**LEGAL ADVERTISEMENT
PORTLAND PLANNING BOARD MEETING**

AGENDA PORTLAND PLANNING BOARD MEETING

ii. Level III Site Plan and Subdivision; 54 Housing Units and Commercial Space; 75 Chestnut Street; Lou Woods representing A & M Partners, Inc., Applicant.

WESTERLEA VIEW LOFTS
75 CHESTNUT STREET
PORTLAND, ME

E-4: Articulation – *Façades visible from public rights of way shall incorporate design elements that break the facades into components scaled to the pedestrian, and to the context of other buildings on the street.*

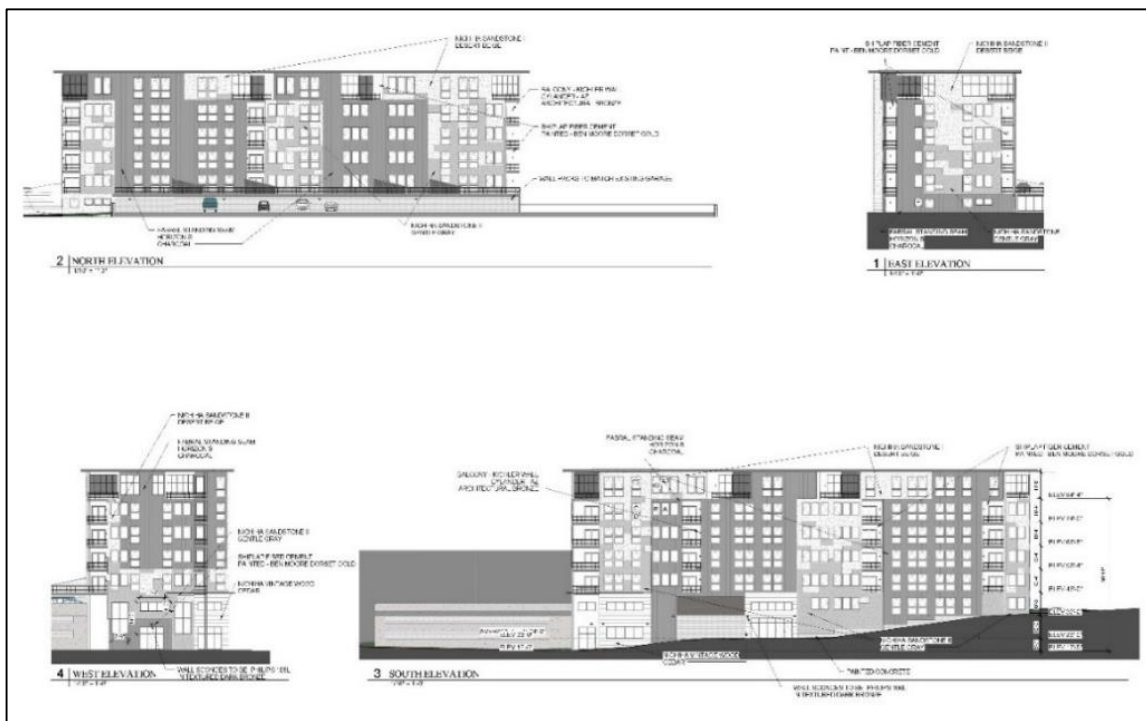
- The project uses fenestration at the ground levels, entrances emphasize with canopies and material change, recessed bays at the upper floors, and open space at the end of the block.
